## Technical Bulletin – May 15, 2015

### 360 Y-DROP™ John Deere 4730/4830

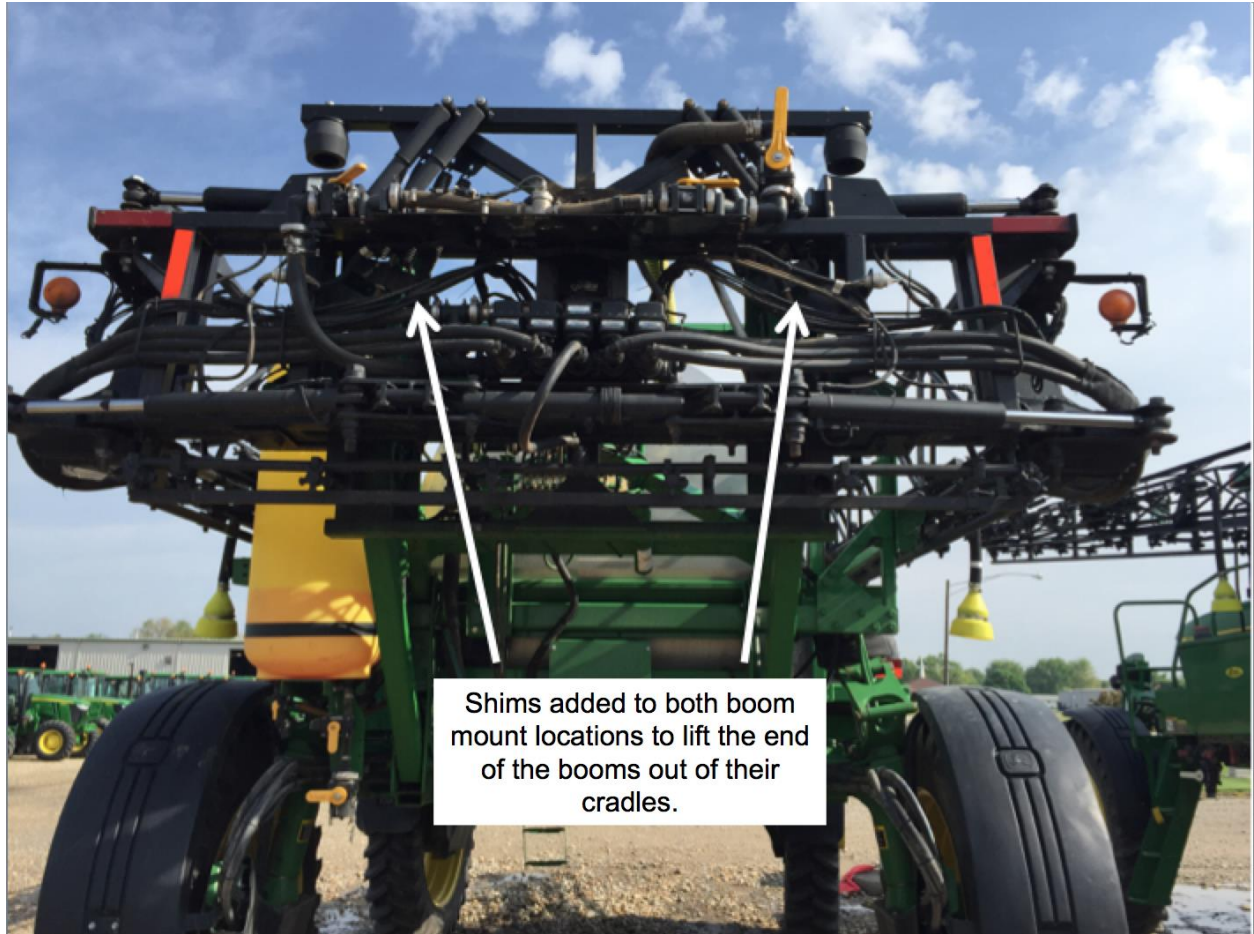
On some models of the John Deere 4730 and 4830 model sprayers, 360 Yield Center dealers and farmers have encountered situations in which the first boom section has difficulty extending out of its cradle after 360 Y-DROP system is installed. This is an issue that some sprayers of this model have encountered without 360 Y-DROP installed. As a result, John Deere has provided a service part for shimming the boom enough to unfold. The John Deere service part number is **N314067**.

If you are experiencing these extension difficulties on your John Deere 4730 or 4830 sprayer, please order the service part from <https://jdparts.deere.com> and see photos below on shim placement to alleviate the issue.

Shims added to both boom mount locations to lift the end of the booms out of their cradles.
